# SAN FRANCISCO PLANNING DEPARTMENT

## Discretionary Review Abbreviated Analysis

*Date:* June 18, 2015  
*Case No.:* 2014-003161DRP  
*Project Address:* 2331 19<sup>TH</sup> STREET  
*Permit Application:* 2014.05.22.6466  
*Zoning:* RH-2 (Residential House, Two-Family) Zoning District  
40-X Height and Bulk District  
*Block/Lot:* 4076/017  
*Project Sponsor:* Karin Payson  
17 Jack Kerouac Alley  
San Francisco, CA 94133  
*Staff Contact:* Richard Sucre – (415) 575-9108  
[Richard.Sucre@sfgov.org](mailto:Richard.Sucre@sfgov.org)  
*Recommendation:* **Do Not Take DR & Approve the Project As Proposed.**

Discretionary Review Hearing  
Case Number 2014-003161DRP  
2331 19<sup>th</sup> Street

**Applicant's Current Proposal  
for South Elevation**  
5/11/15

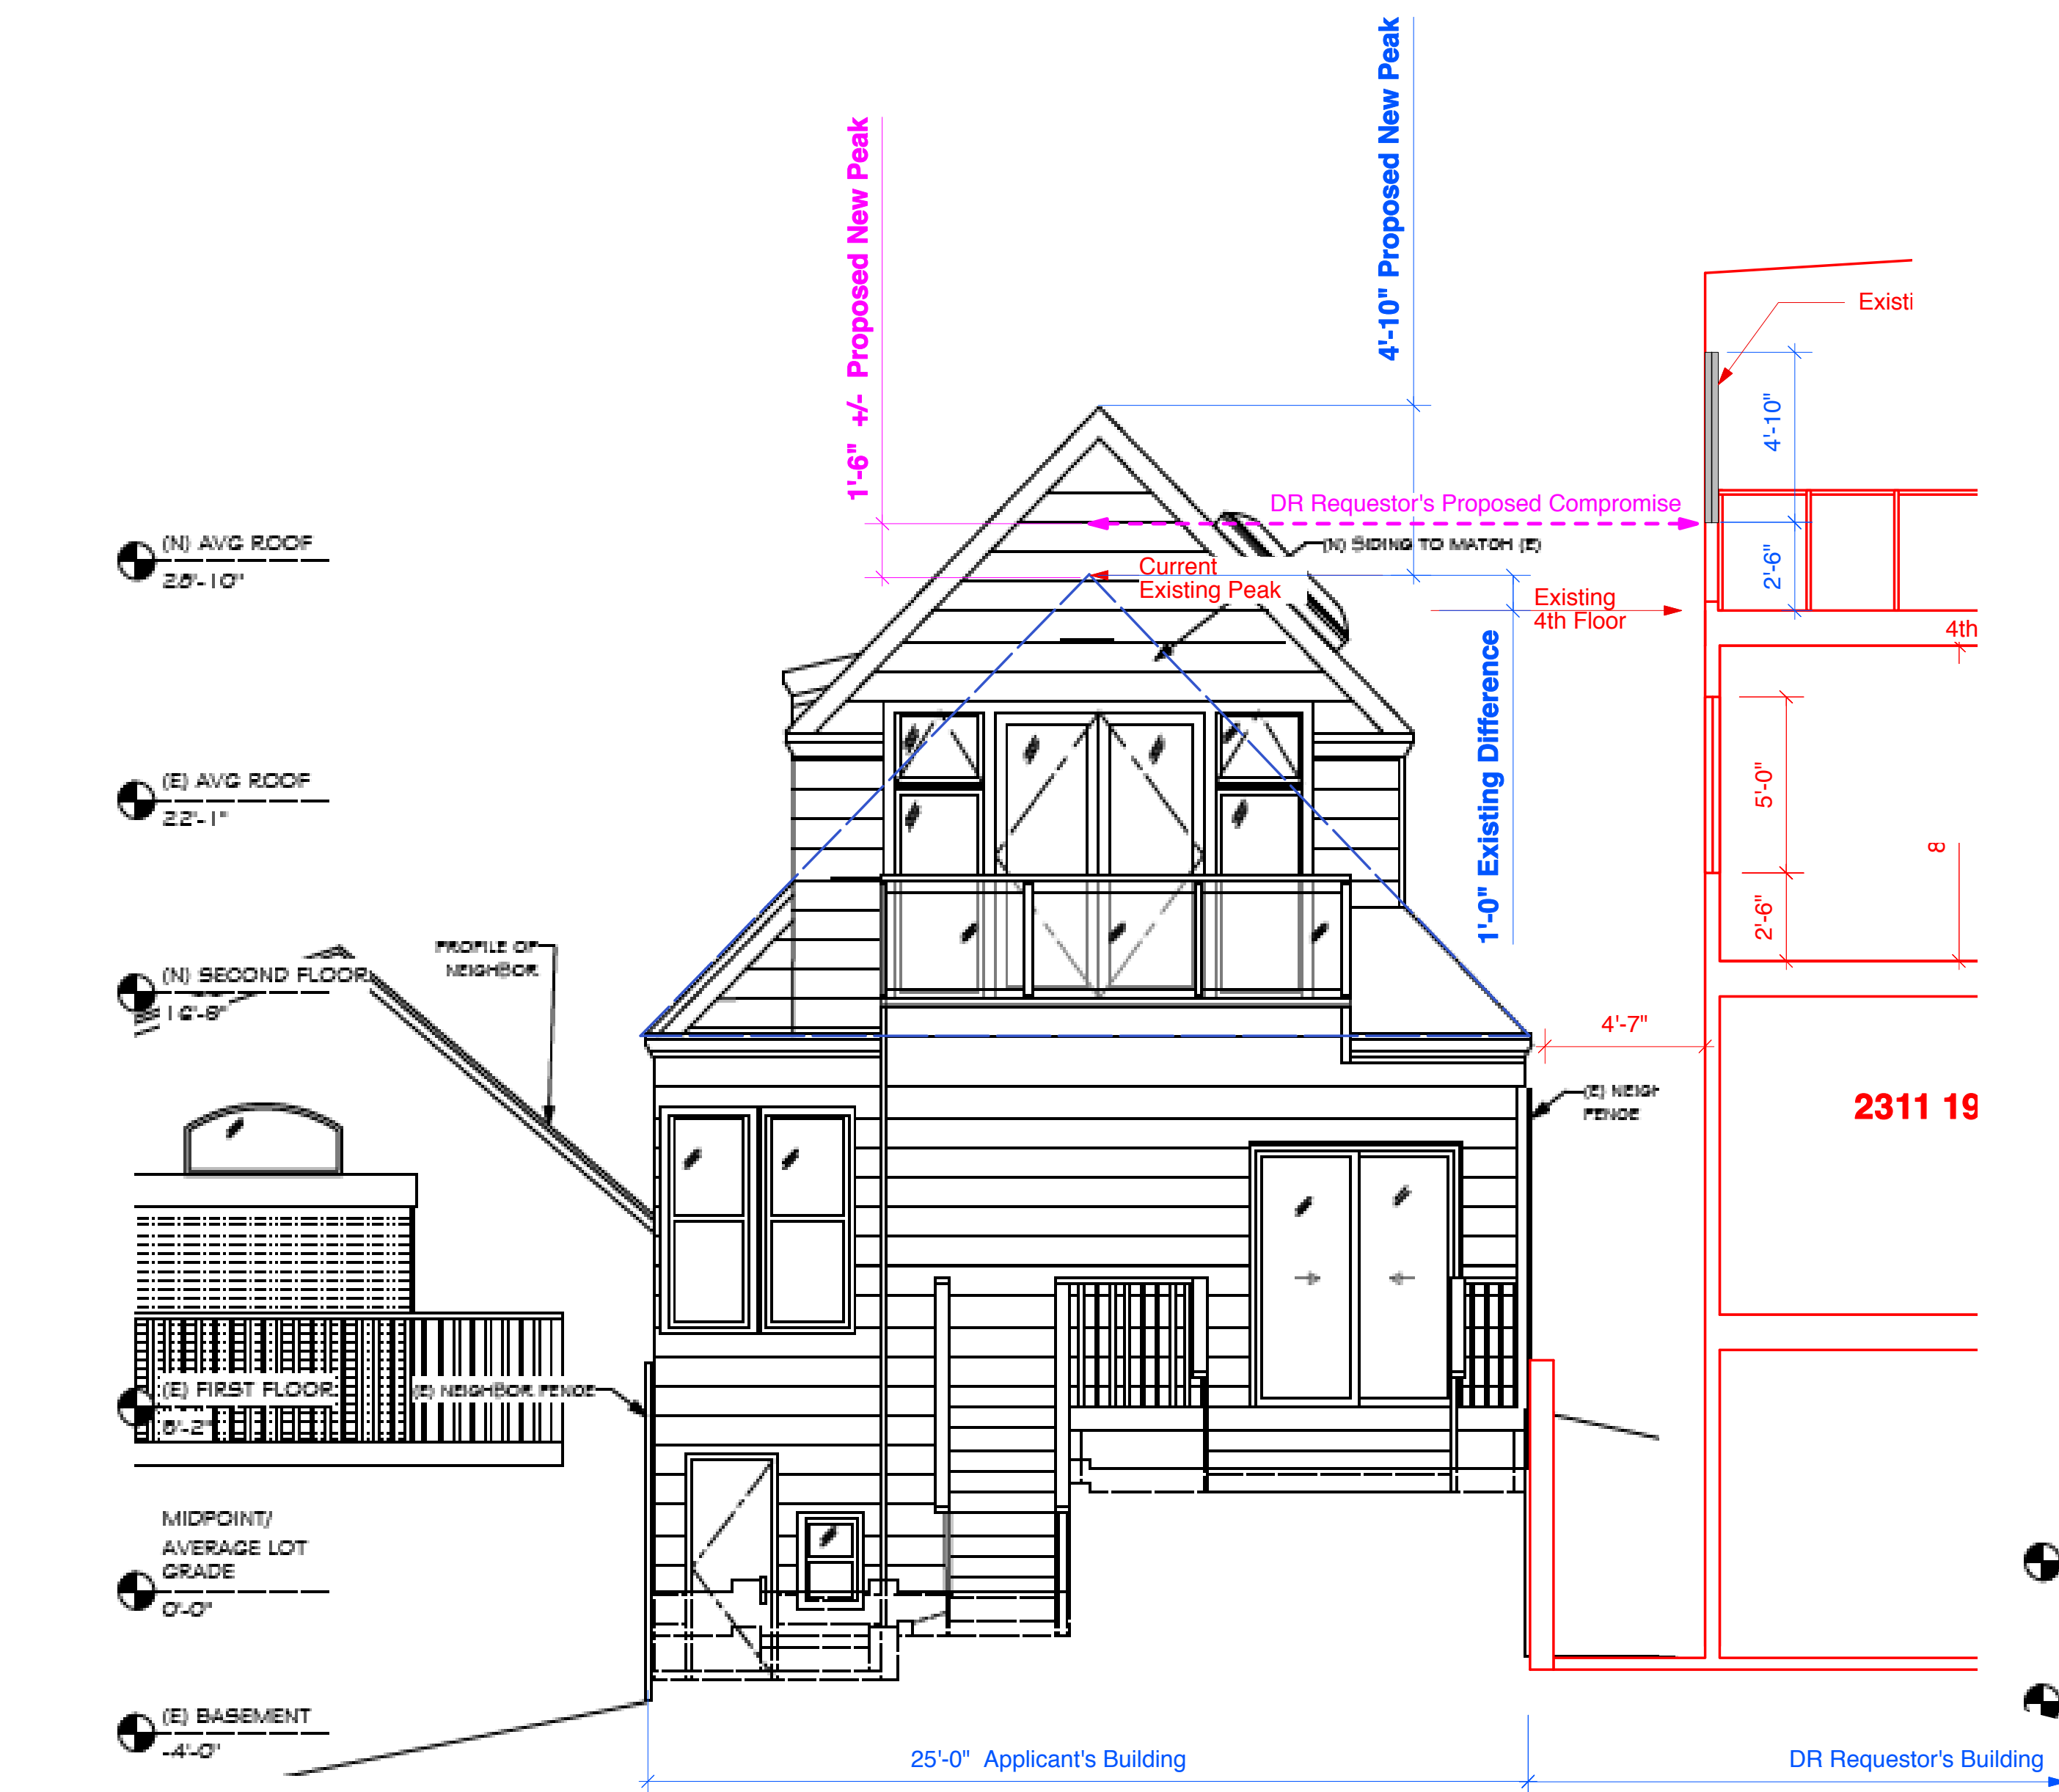
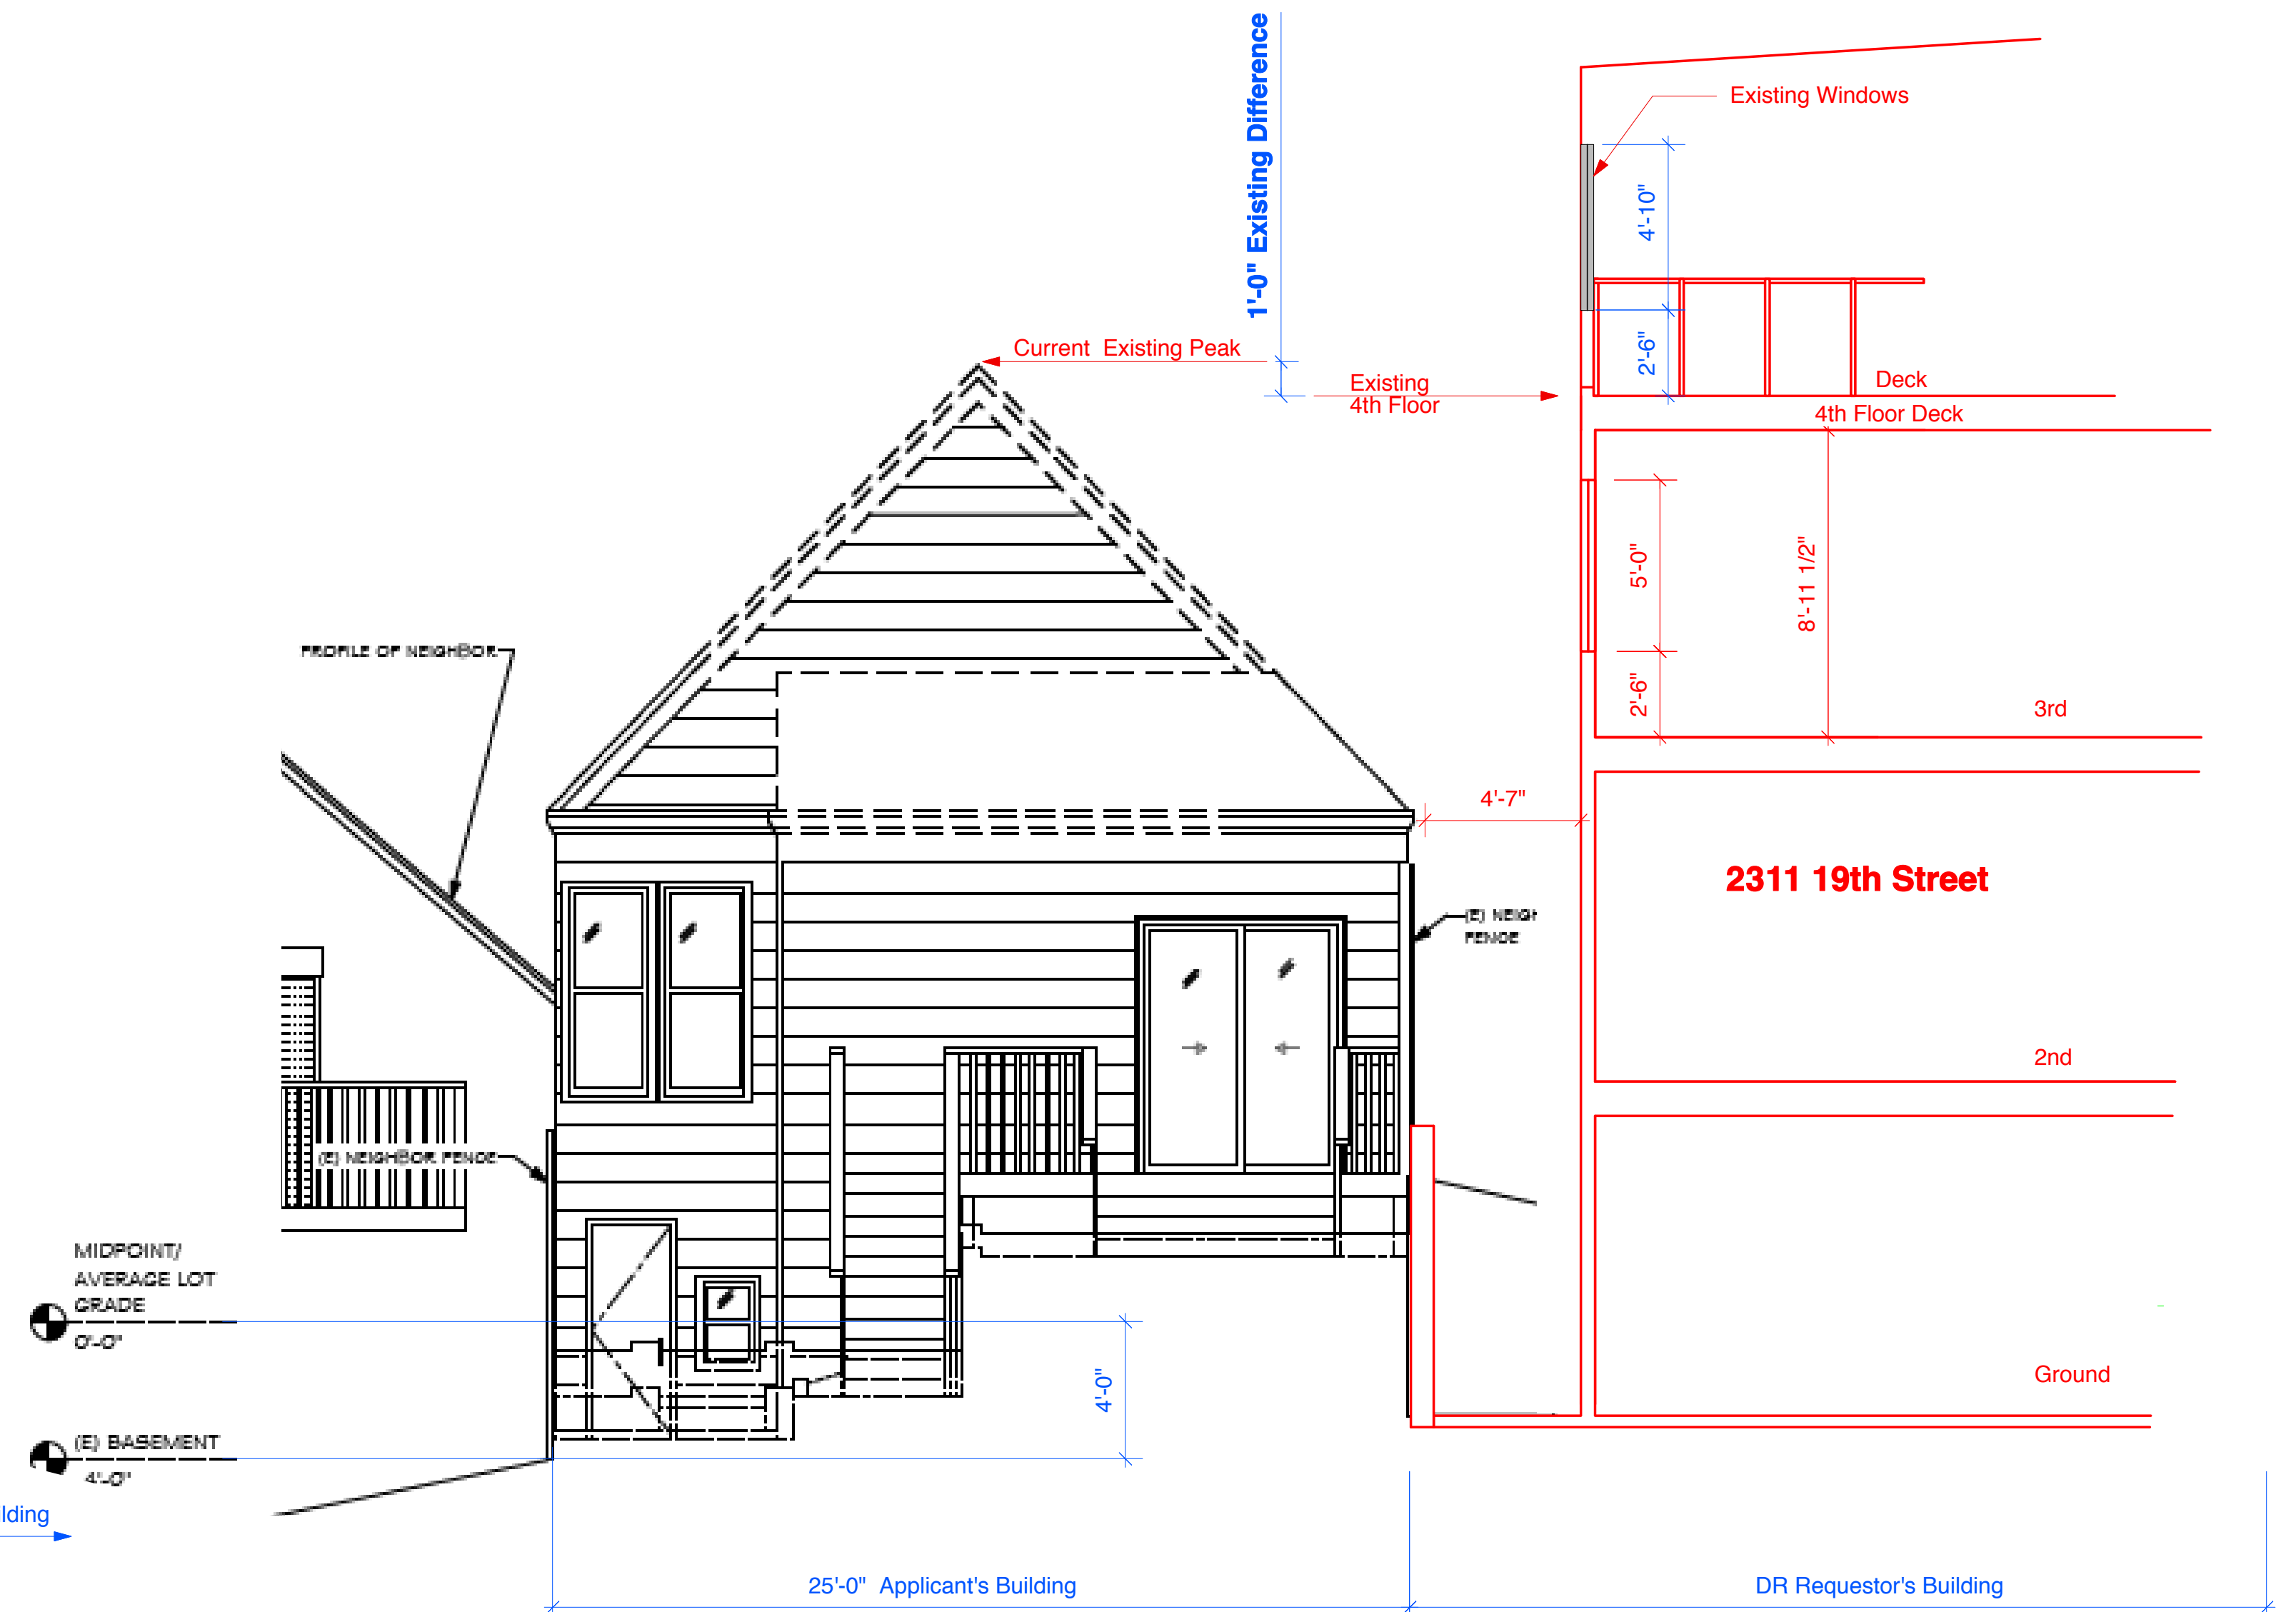
Since filing our request for discretionary review, we have had a number of meetings and conversations with our neighbors the project sponsors and their architect. We have been hoping that we could reach a compromise with them, and have submitted two different compromised designs. The first was flatly rejected and there has been no response to the second. This addendum briefly presents our recent compromise design and addresses our on-going concerns with their plans. Specifically, we are still concerned that Project Sponsor's drawings contain inaccuracies and that their proposed project is out of sync with the surrounding properties and does not respect the neighborhood topography.

- (3) Project Sponsors proposed to replace the glass rail on their roof deck with a privacy wall. Because a tall wood privacy wall would have a negative effect on the light to our home, and cause the addition to seem even larger than proposed, we declined the proposal.

We appreciate the challenges in such a major construction project, and have worked in good faith to reach a resolution. Unfortunately, Project Sponsors have rejected our efforts to reach a private compromise. We therefore respectfully request that you exercise your powers to revise the project, and accept our second proposed compromise, which will give Project Sponsor's all the square footage they seek, a cathedral ceiling in the master suite, but better correspond to the surrounding properties and protect our light and rear yard open space.
